RE: ANL Peer Review Draft Report (December 1, 2016) entitled "Evaluation of Pressure Rating Methods Recommended by API 17TR8"

**API CSOEM Multi-Subcommittee Task Group
Technical Response
to**

**Argonne National Laboratory Draft Report on
Evaluation of Pressure Rating Methods Recommended by API RP 17TR8
dated December 1, 2016**

February 15, 2018

Figure 1 - Representative True Stress-Strain Material Curve

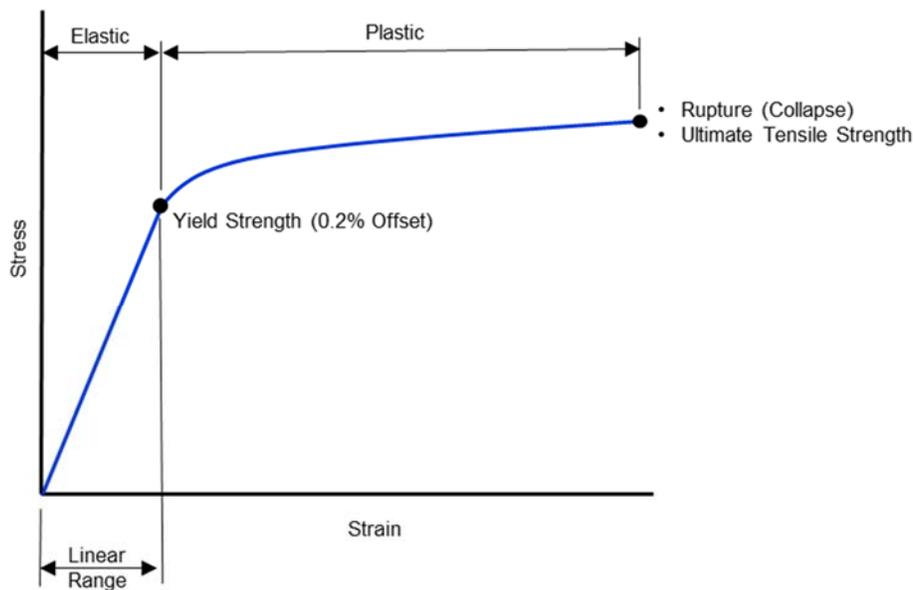
The ANL study further progressed the hydrotest to the test body's burst pressure; however, strain-gauging data were not reported up to the burst pressures (Large Neck = 67,959 psi; Small Neck = 51,469 psi) or in the plastic region of the material model, from the onset of yielding up to the burst/collapse pressure. Figure 6.4 and Figure 6.5 of the ANL draft report show that the strain gauge is mounted on the test body during the burst test, however, the strain reading was not collected. Subsequently, the actual burst pressures were compared to the theoretical collapse pressure leading towards the calculations of the test body pressure rating.

Note: Refer to Figure 1 – Representative True Stress-Strain Material Curve, for illustration of the relationship between the linear range and the plastic region on a material model curve.

**Figure 3 – Conformity Assessment to API 17TR8 Integrated Process
 HPHT Design Flow Chart**

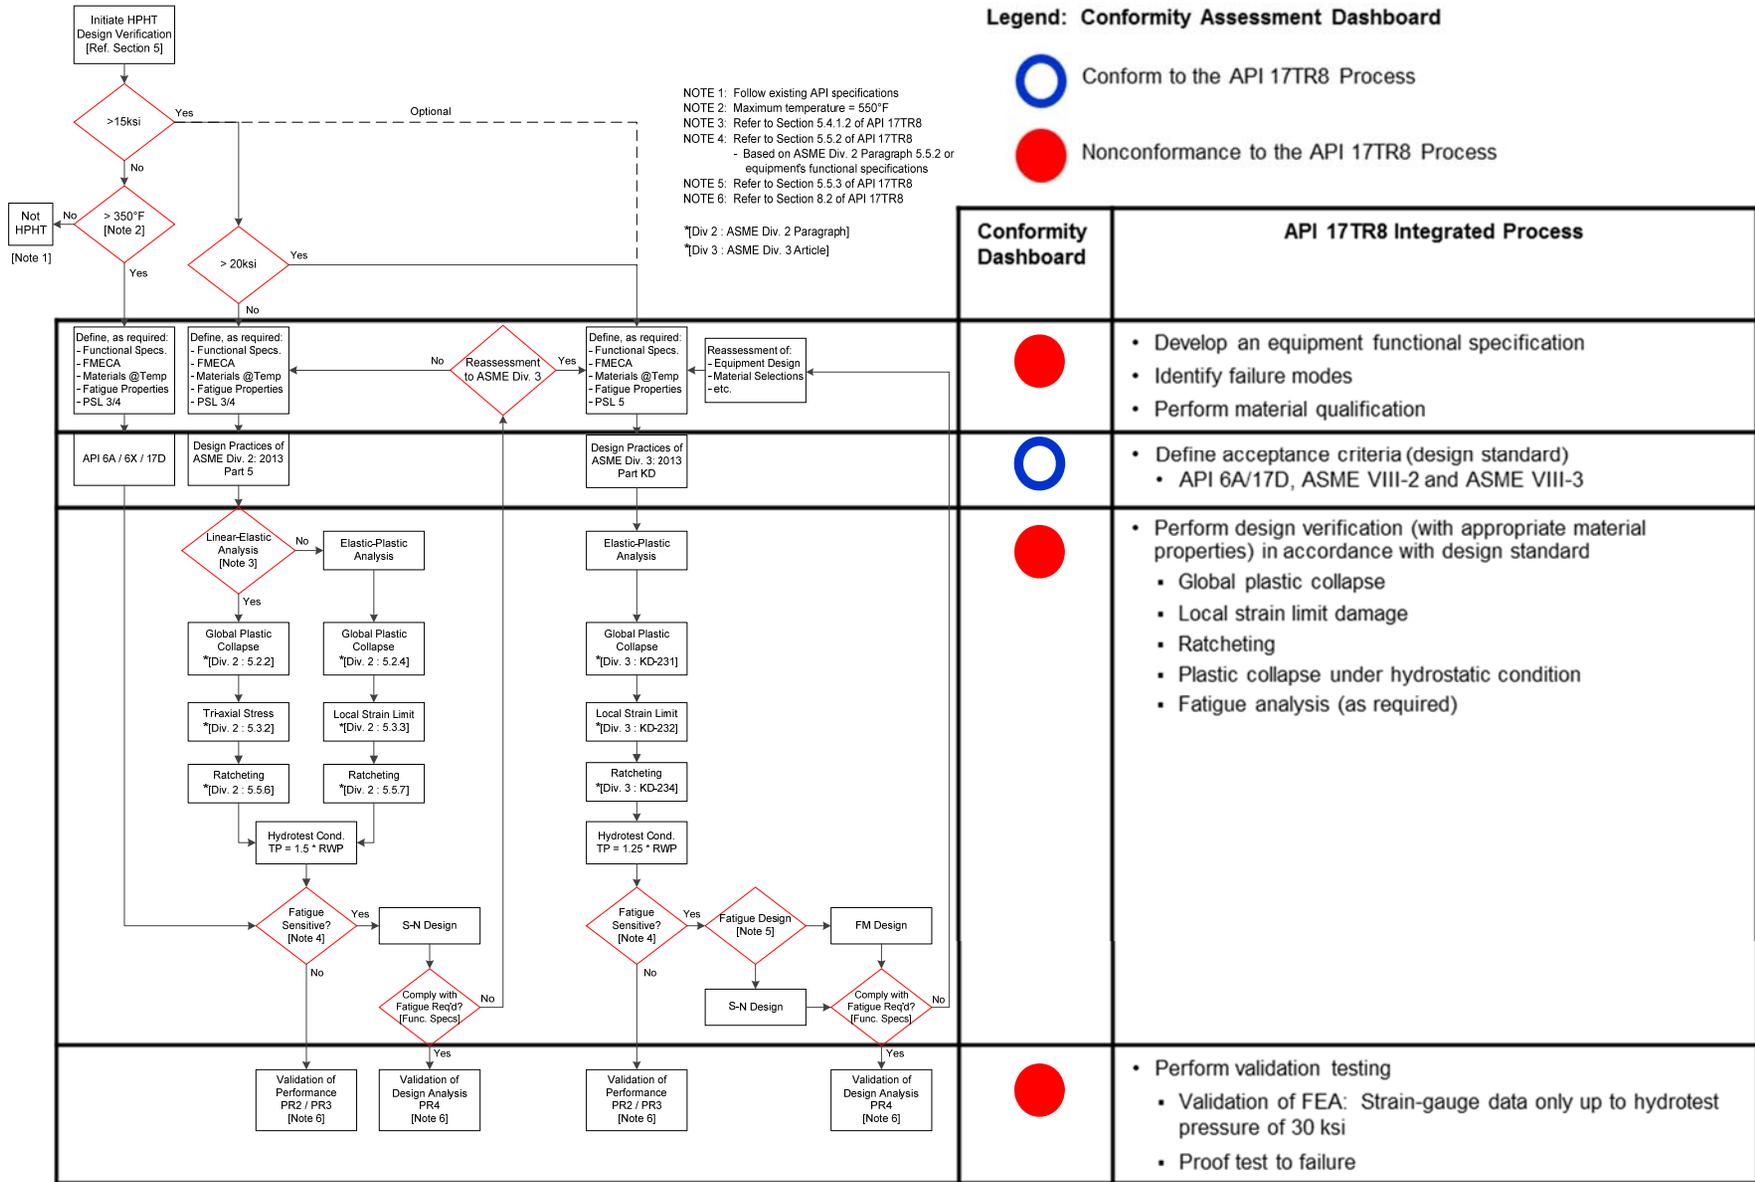
As discussed in Section 5.2.1 above and illustrated in Figure 3 – Conformity Assessment to API 17TR8 Integrated Process: HPHT Design Flow Chart, the ANL did not deploy the integrated process in their application of API 17TR8 for the study. API 17TR8 specifies an integrated process for HPHT equipment design that requires thorough assessment of the equipment functional requirement, material qualification, design verification for adequate protection against potential failure modes and validation testing. These processes must be adhered to for demonstration of the equipment's fit-for-service in HPHT application. The ANL did not perform the study in accordance with API 17TR8 nor did it use the document's holistic approach for the calculations of the test body pressure rating.
